Bob-Cat

Service Bulletin 388

Kawasaki FH500V Fan Housing Screen

Midsize Models Affected: 930007, 930307

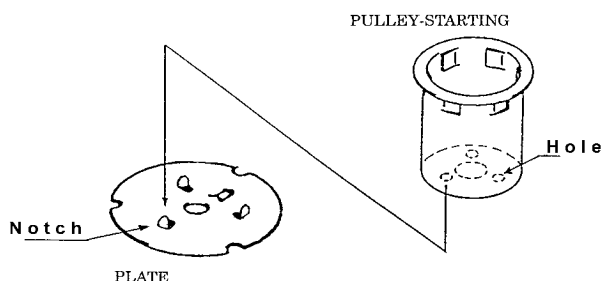
Under certain operating conditions, grass may accumulate on the rotating screen. If the screen is not cleaned from time to time, it will block the cooling airflow to the engine. This problem occurs only on the recoil starter versions.

Replace existing rotating screen with a new steel rotating screen (Kawasaki #14037-7006-9H) as per attachments.

1. Remove the recoil starter case by unscrewing the nuts (4 pcs.).
 * The studs which come out of the fan housing may also be loose. If so, hold the studs with a wrench and remove only the nuts on the recoil starter case.
2. Remove the fan housing by unscrewing the bolts (4 pcs.).
3. Remove the starter pulley by unscrewing the nut.
4. Remove the plastic screen.
5. Clean debris for the cylinder, cylinder head fins and engine shroud.
6. Install the new metal screen (New Part No. 14037-7006-9H).
 * Make sure that tabs on the screen and slots on the fan match together

7. Install the pulley.
 * Make sure that the notches on the plate go into the holes on the pulley.

- * Make sure that the direction of the washer is correct.

- * Torque the bolt to 40 ft/lbs.
8. Install the recoil starter case.
